CHANGE ORDER #104
DEFINITION OF THE PROJECT
DEFERRED APPROVAL
1/24/2011

**CHILDREN'S HOSPITAL
OF ORANGE COUNTY**

**LOWER LEVEL MECHANICAL
PLAN AREA - F**

M3.0F

LOWER LEVEL MECHANICAL PLAN AREA - F

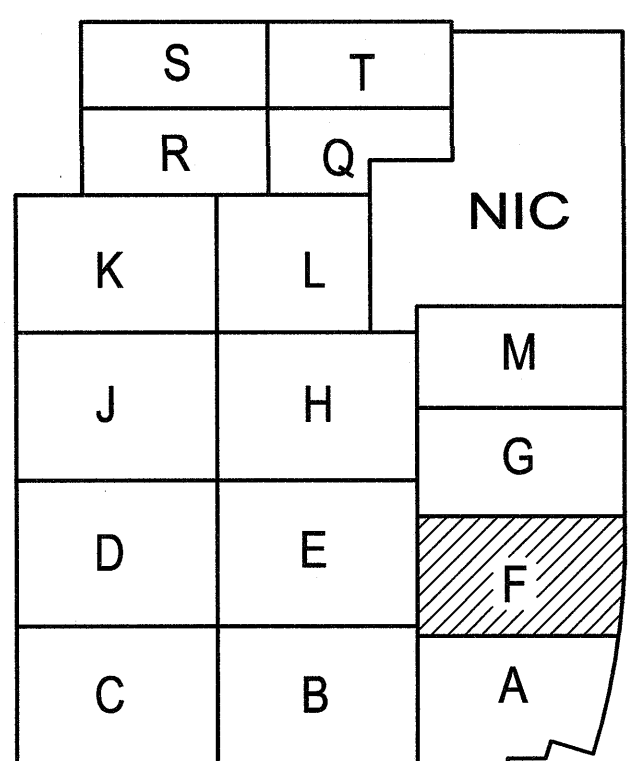
RFI 3540- Relocate
steam drip legs,
chilled water drain
and 3" chilled water
pipe per MEOR
report dated 4/15/11

RFI 3870-
Penetration E3

RFI 3267 Floor mount
pipe supports

RFI 3498- HX 1
& 2 VFD
location and
mounting

RFI #5396

RFI #6056

RFI #5095
Relocate North to
allow clearances
for installation.

RFI #6058
